Detailed Site Plan

Que for the People (Federalist Pig)

DSP-19072

SUBJECT: Detailed Site Plan DSP-19072
Que for the People (Federalist Pig)

WESTERN FAÇADE OUTDOOR DINING AREA

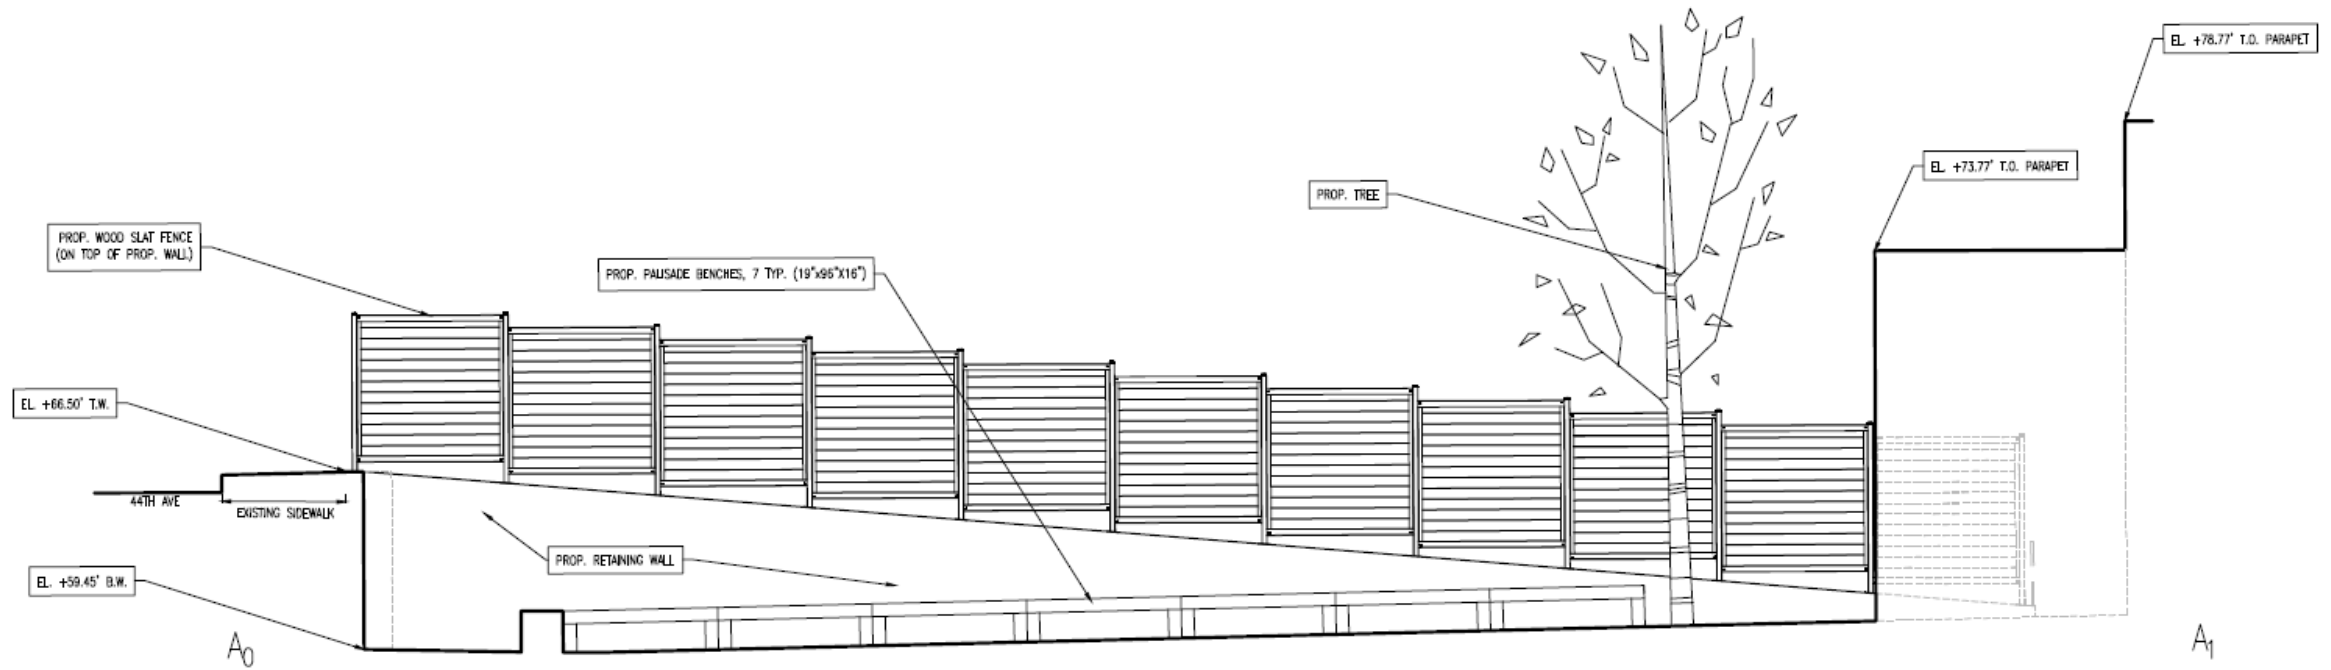
- a. Update the detail for the gates of the trash enclosure to match the wood slat fence utilized around the outdoor dining area.
 - b. The proposed wood slat fence should be shortened to four feet in height and is included as a condition.

- c. Add a design detail of the retaining wall at the outdoor dining area.
 - d. Show height and gross floor area of the proposed one-story addition on the plan.

SIGNAGE

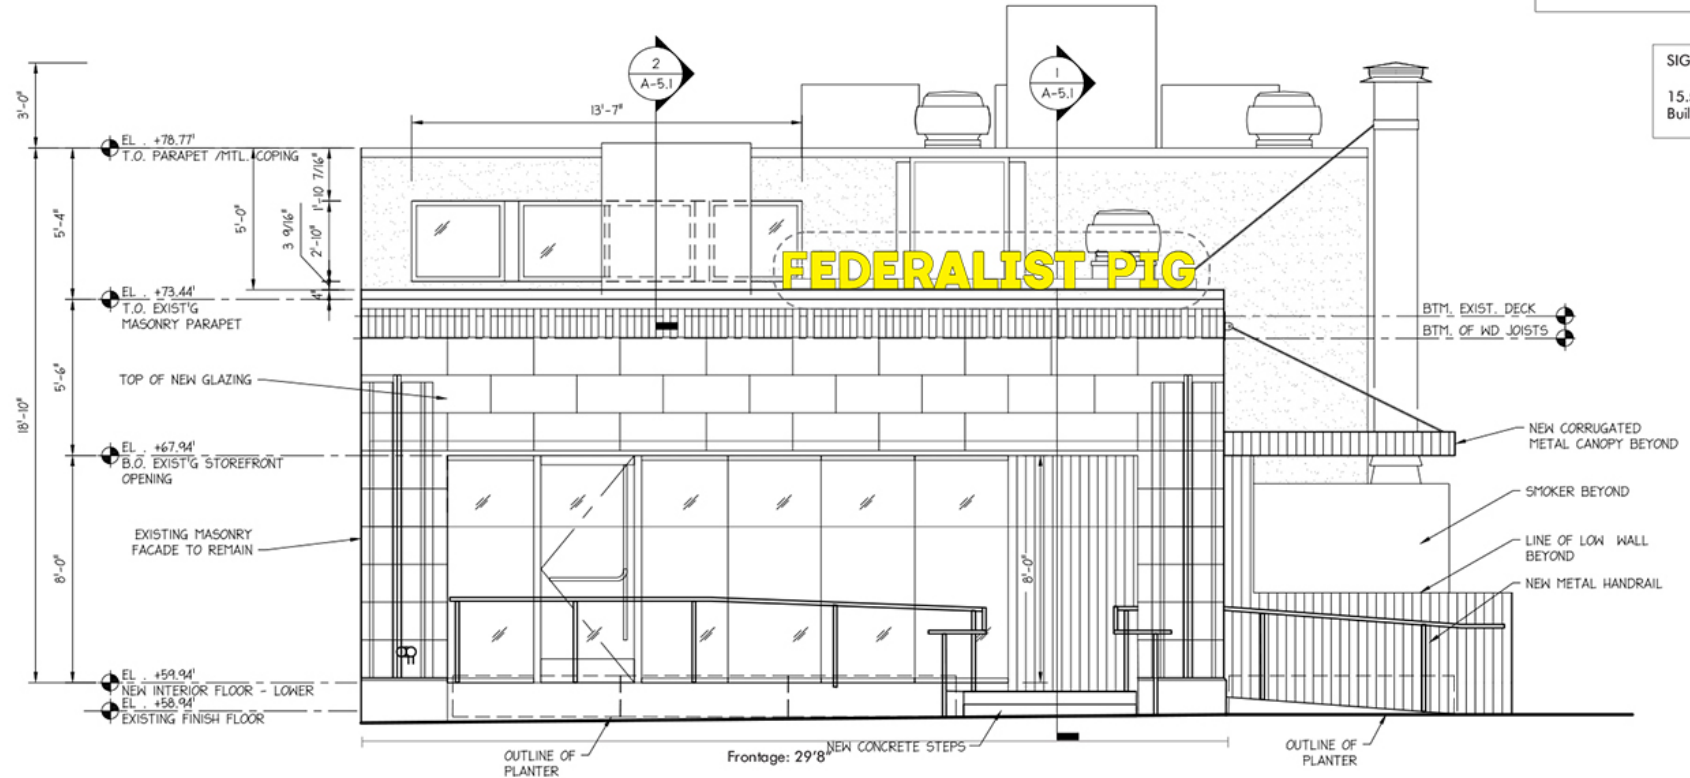
An 18.59-square-foot internally lit “Federalist Pig” sign is proposed on the top of the façade wall above the entrance stairs. Along the side of the building, a handicap-accessible entrance will be provided by a ramp to the front door. On the northern façade of the building facing the parking lot, a mural will be a painted, which will contain no advertising and is intended to provide an artistic element to a building located in the Arts District.
